ADDENDUM NO. 10

February 15, 2010

Project: **Package C – 2009: Holbrook Elementary School Renovations**
 Cypress-Fairbanks Independent School District

Bay Project No.: 0840 (10-01-2069R-FP)

ADD10-SKE-01

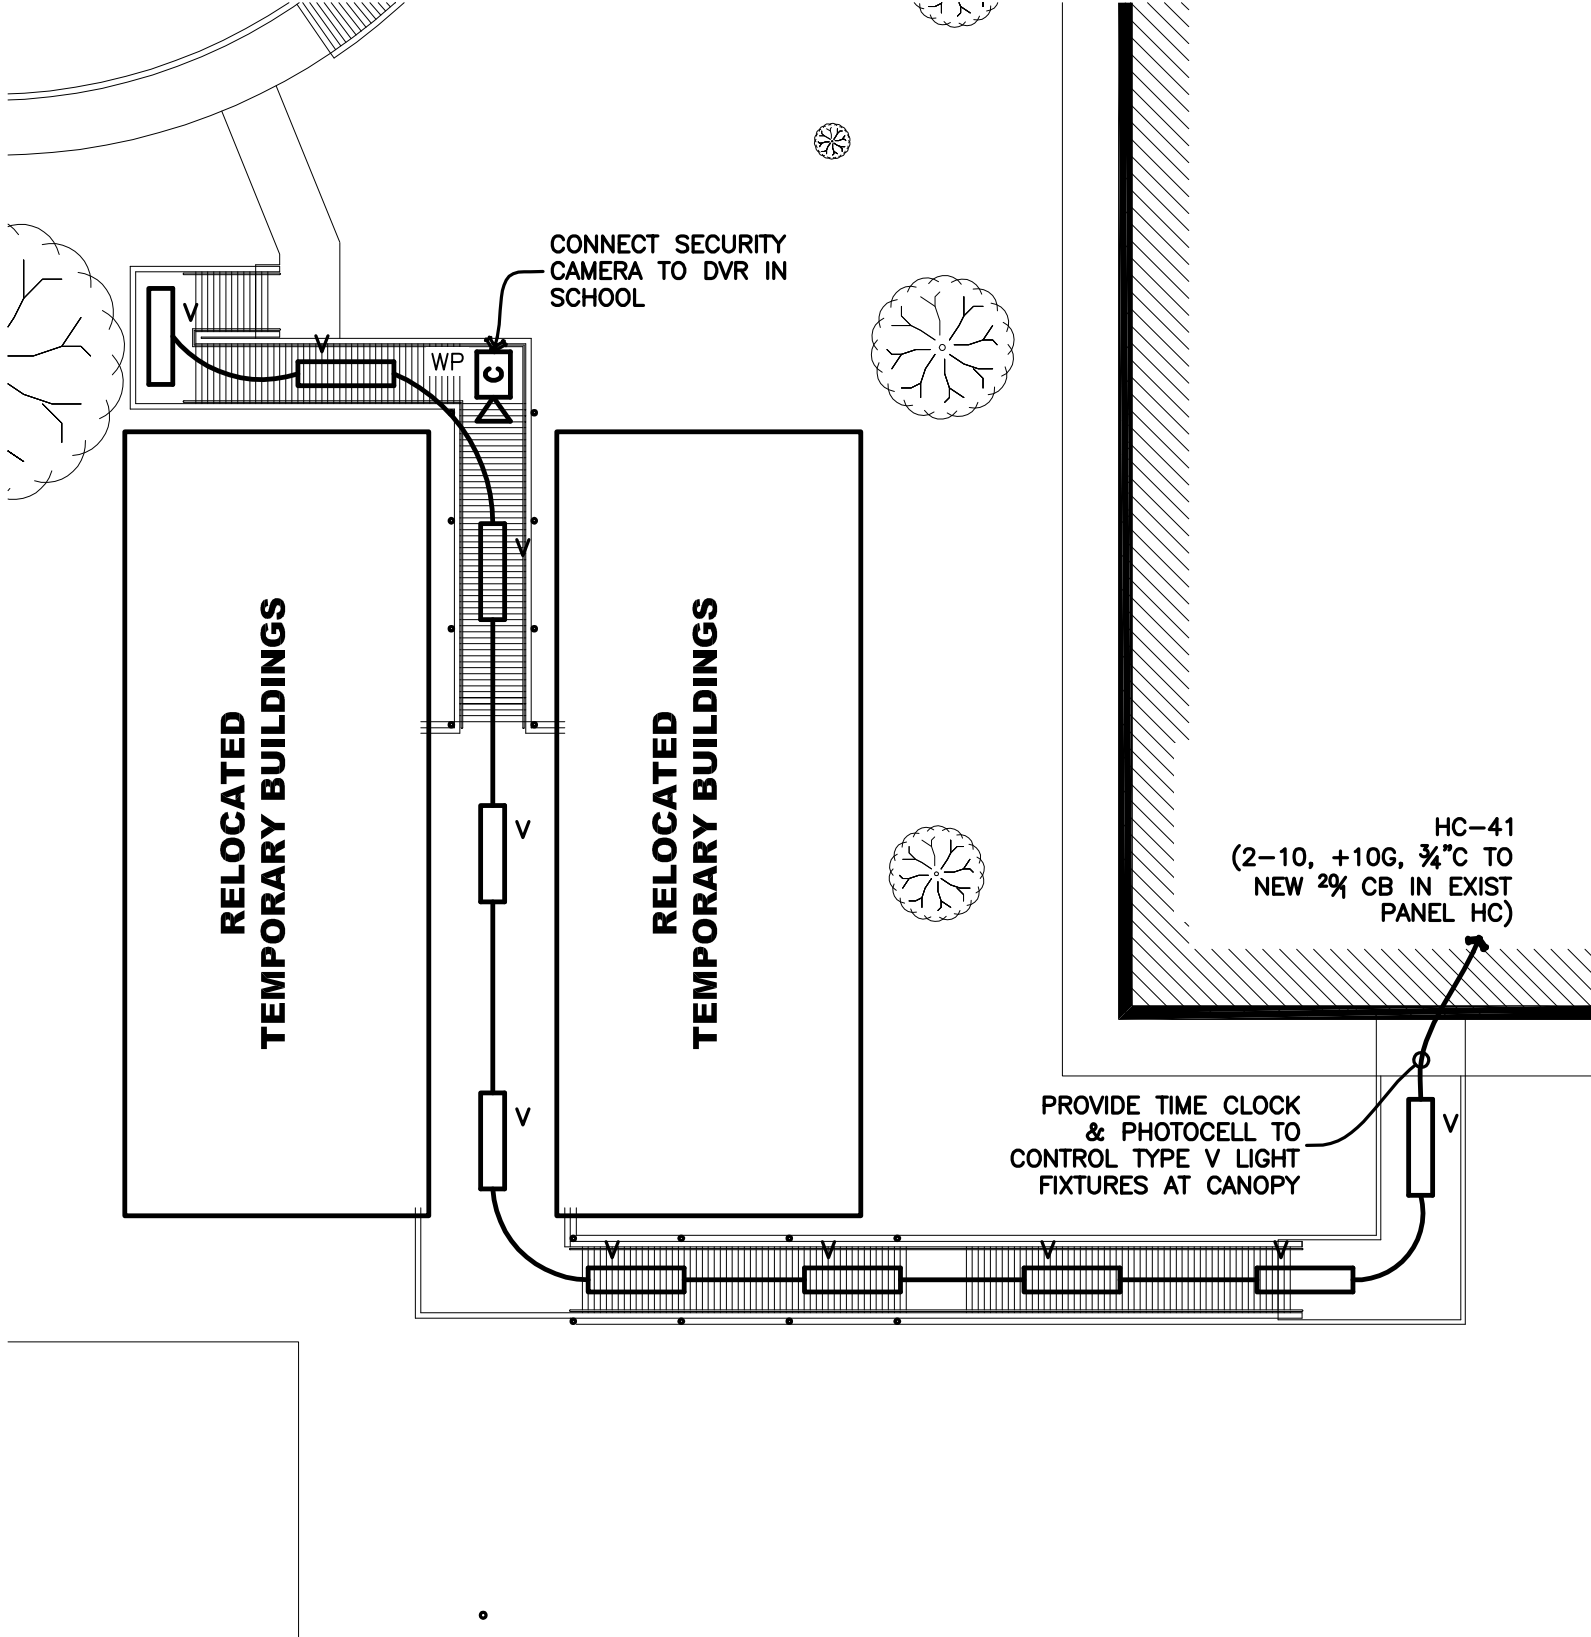
- a. See attached Sheets ADD10-SKE1 & ADD10-SKE2 for lights and security cameras at T-Bldgs.
2. Sheet M1.1 – Mechanical Floor Plan – Area A
 - a. Mechanical for Portable Buildings shall be per attached Sheets ADD10-SKM1.

ADDM 10-SKE-03
 0840/0832
 SCALE: NO SCALE
 02/15/2010
 RE: E3.1

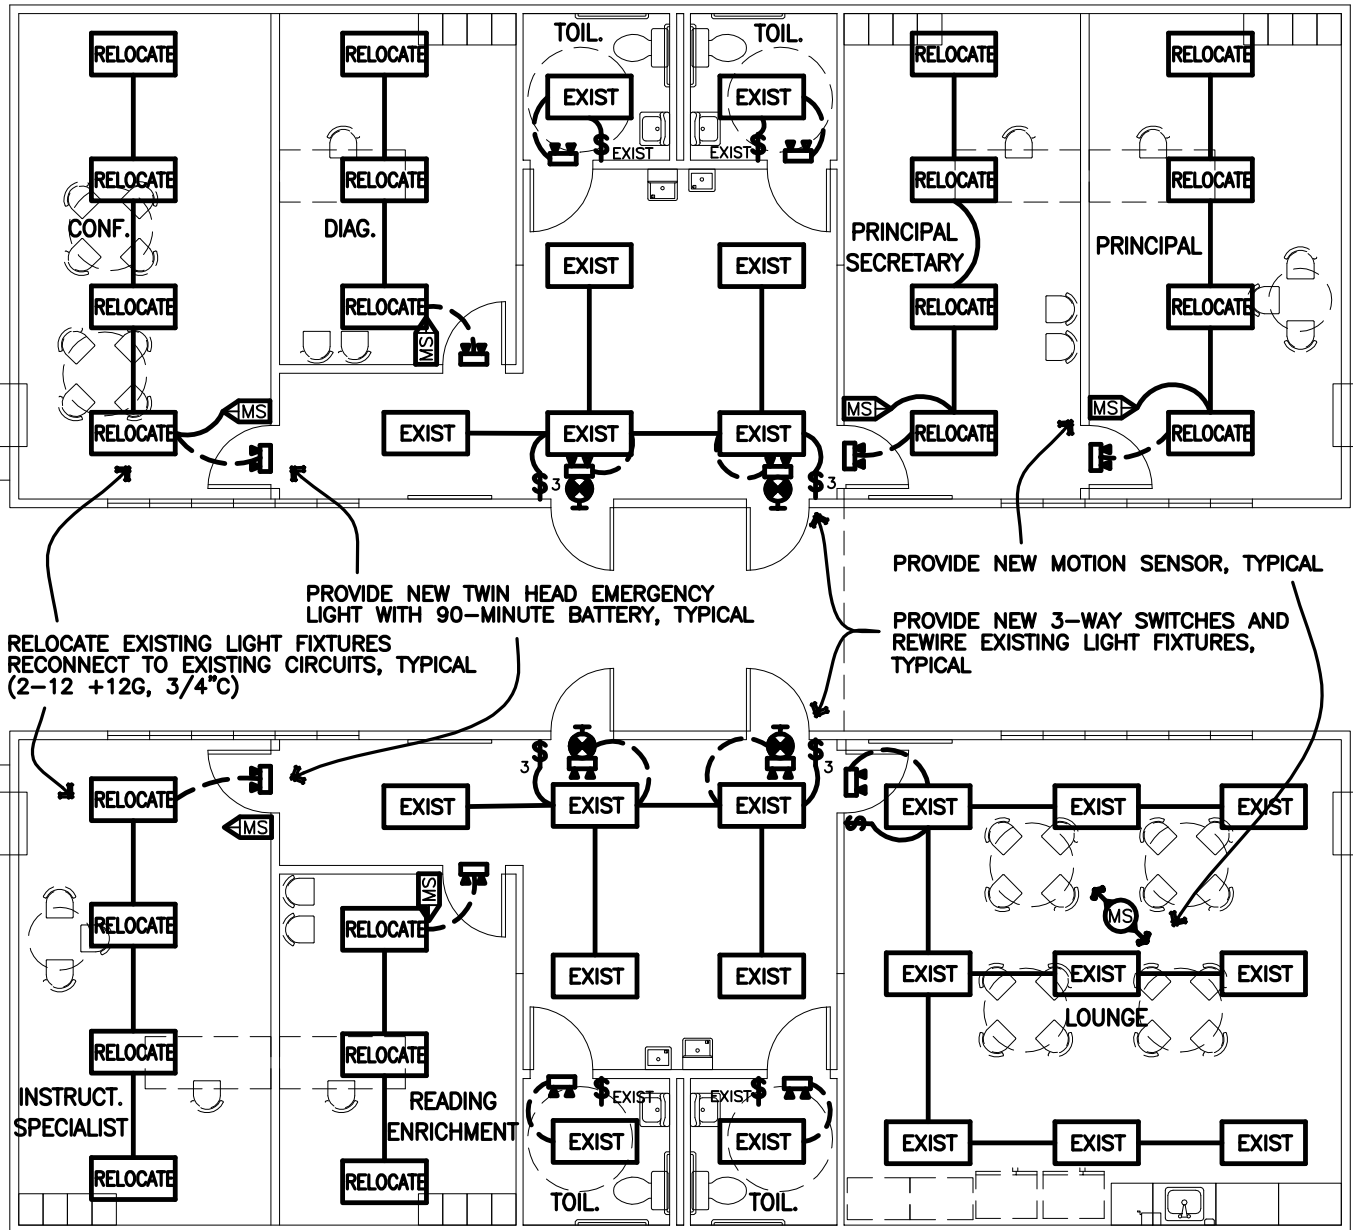
10. Sheet E1.8– Electrical Floor Plan – Area D
 - c. Classroom D516: Move student computers and data outlets from south wall to north wall.
 - a. MDF Room: Install three quad receptacles above three data racks and connect to wall receptacle circuits ELF-5, ELF-7 & ELF-15. Also, install one quad receptacle above security CCTV cabinet and connect to wall receptacle circuit ELF-17. Lastly, provide one data drop for existing CCTV DVR. Provide two data drops for new CCTV cabinet.
 - b. See attached Drawing ADD10-SKE3 for electrical requirement at Temp. Reception.

15. Sheet E3.1 – Electrical Wiring Schematic for T-Building
 - a. Drawing 4, Fire Alarm / Data / PA & Security Layout for relocated existing school T-Bldgs, Typical of Five (5): Add one data drop and one 120V receptacle for each T-Bldg for wireless data equipment, field verify location. Connect 120V receptacle to local 20A receptacle circuit (2-12, +12G, ¾"C).
 - b. Drawing 3, Fire Alarm / Data / PA & Security Layout for two Admin. T-Bldgs: Revise per attached Drawings ADD10-SKE3 & ADD10-SKE4.

ADD10-SK1 0840/0832 NO SCALE 2/15/2010
--	--

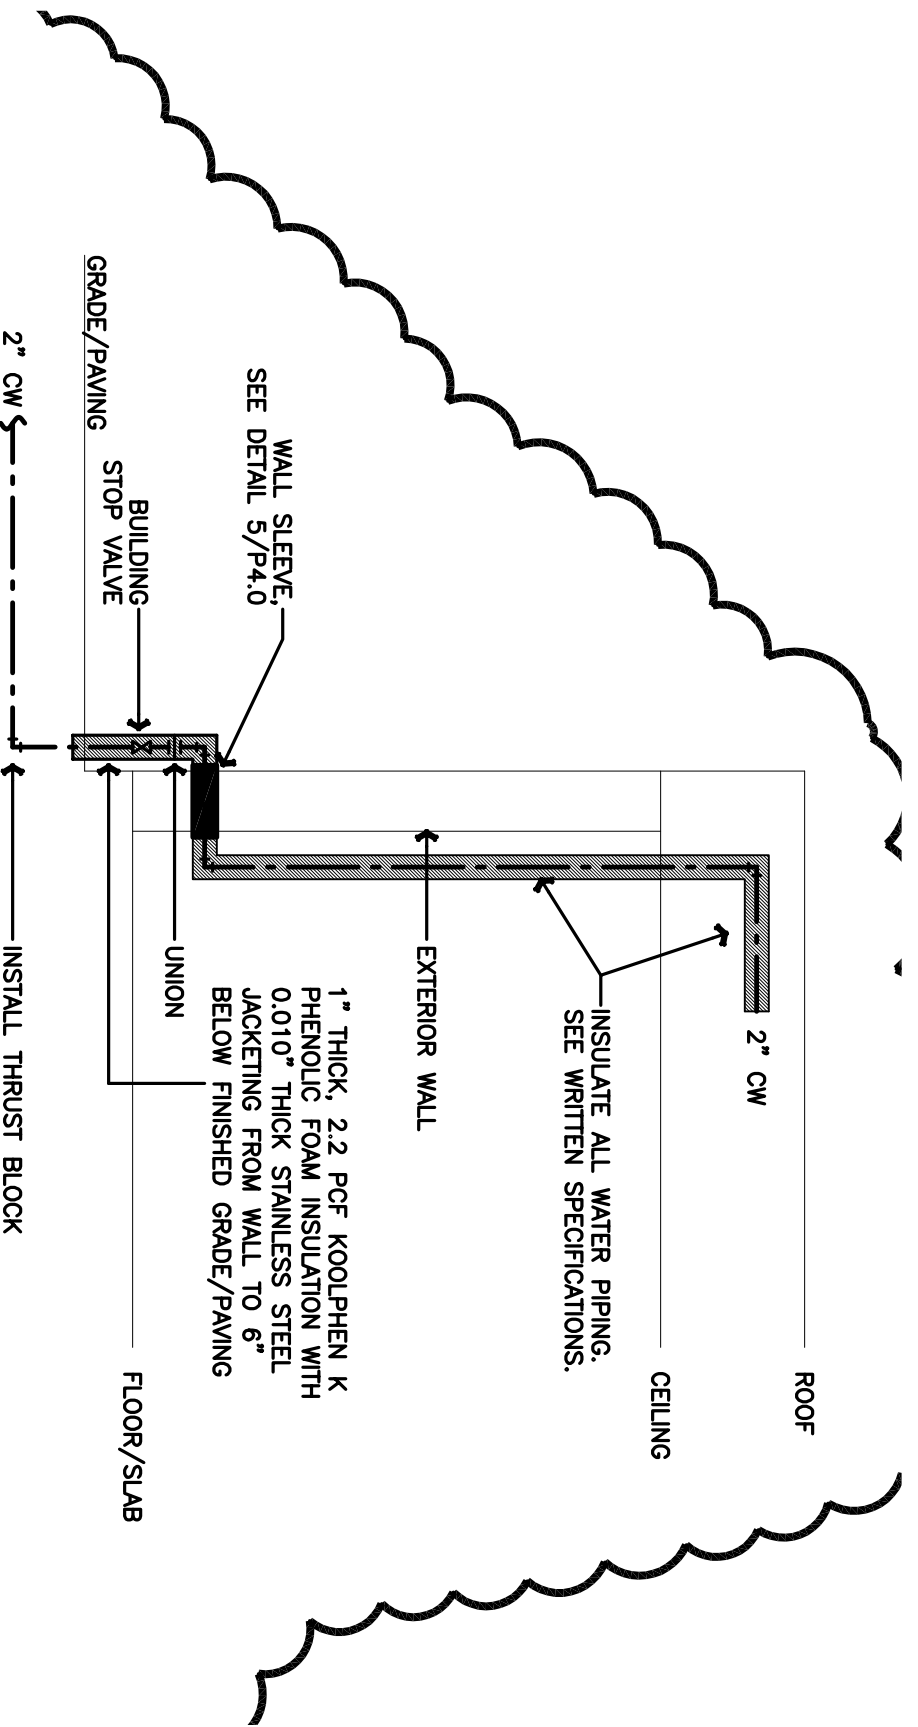
20. Sheet E5.0 – Light Fixture Schedule
 - a. Type W/WX: Provide two (2) 2-lamp ballasts.
21. Sheet P2.0 – Plumbing Floor Plan – Area A
 - a. Add Detail 4 – Building CW Entry/Exit Detail per attached Drawing ADD10-SKP1.
22. Sheet P2.3 – Plumbing Floor Plan – Areas D & E
 - a. Plumbing for Portable Buildings shall be per attached Drawing ADD10-SKP2.
